PRODUCT CHANGE NOTIFICATION (PCN)

A-MCUP-80070/Y MODULAR CABLE

CHANGE NOTIFICATION: PCN 20220425_A-MCUP-80070/Y

DESCRIPTION OF CHANGES: CHANGE OF DATA SHEET
CHANGE OF DATA SHEET
New Draw.-No. ASS_7407_CArev04

ASS 7407 CA

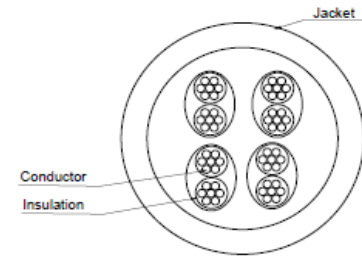
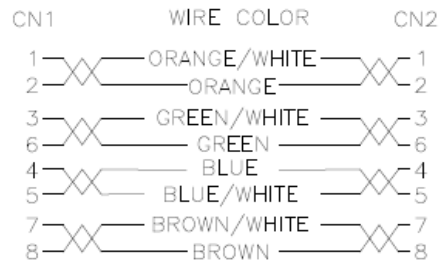
A-MCUP-80070/Y	OLD VERSION	A-MCUP-80070/Y	NEW VERSION																																
<p>Appearance</p>		<p>Appearance</p>																																	
<p>BOM</p> <table border="1"> <thead> <tr> <th>NO.</th> <th>NAME.</th> <th>QTY</th> <th>SPECIFICATION</th> </tr> </thead> <tbody> <tr> <td>③</td> <td>Molding PVC</td> <td>2</td> <td>Molding PVC 45P</td> </tr> <tr> <td>②</td> <td>RJ45 CONN</td> <td>2</td> <td>RJ45 8P8C, Two Fork gold plated contacts 3u" gold</td> </tr> <tr> <td>①</td> <td>CABLE</td> <td>1</td> <td>UTP(26AWG*x1PR)*4+PVC OD:4.9±0.2mm</td> </tr> </tbody> </table>		NO.	NAME.	QTY	SPECIFICATION	③	Molding PVC	2	Molding PVC 45P	②	RJ45 CONN	2	RJ45 8P8C, Two Fork gold plated contacts 3u" gold	①	CABLE	1	UTP(26AWG*x1PR)*4+PVC OD:4.9±0.2mm	<p>BOM</p> <table border="1"> <thead> <tr> <th>NO.</th> <th>NAME.</th> <th>QTY</th> <th>SPECIFICATION</th> </tr> </thead> <tbody> <tr> <td>④</td> <td>⚠ Molding PVC</td> <td>2</td> <td>Molding PVC 65P</td> </tr> <tr> <td>④</td> <td>⚠ RJ45 CONN</td> <td>2</td> <td>RJ45 8P8C, contacts 3u" gold-plated Un-shielded PC UL94V-2</td> </tr> <tr> <td>④</td> <td>⚠ CABLE</td> <td>1</td> <td>CAT 5E U/UTP(26AWGx1PR)*4+PVC Jacket OD:4.9±0.2mm</td> </tr> </tbody> </table>		NO.	NAME.	QTY	SPECIFICATION	④	⚠ Molding PVC	2	Molding PVC 65P	④	⚠ RJ45 CONN	2	RJ45 8P8C, contacts 3u" gold-plated Un-shielded PC UL94V-2	④	⚠ CABLE	1	CAT 5E U/UTP(26AWGx1PR)*4+PVC Jacket OD:4.9±0.2mm

NO.	NAME.	QTY	SPECIFICATION																																
③	Molding PVC	2	Molding PVC 45P																																
②	RJ45 CONN	2	RJ45 8P8C, Two Fork gold plated contacts 3u" gold																																
①	CABLE	1	UTP(26AWG*x1PR)*4+PVC OD:4.9±0.2mm																																
NO.	NAME.	QTY	SPECIFICATION																																
④	⚠ Molding PVC	2	Molding PVC 65P																																
④	⚠ RJ45 CONN	2	RJ45 8P8C, contacts 3u" gold-plated Un-shielded PC UL94V-2																																
④	⚠ CABLE	1	CAT 5E U/UTP(26AWGx1PR)*4+PVC Jacket OD:4.9±0.2mm																																
<p>FOR DETAIL, PLEASE TAKE ATTACHED NEW DRAWING: FOR REFERENCE</p>

④	△	Molding PVC	2	Molding PVC 65P
④	△	RJ45 CONN	2	RJ45 8P8C, contacts 3u" gold-plated Un-shielded PC UL94V-2
④	△	CABLE	1	CAT 5E U/UTP(26AWGx1PR)*4+PVC Jacket OD:4.9±0.2mm
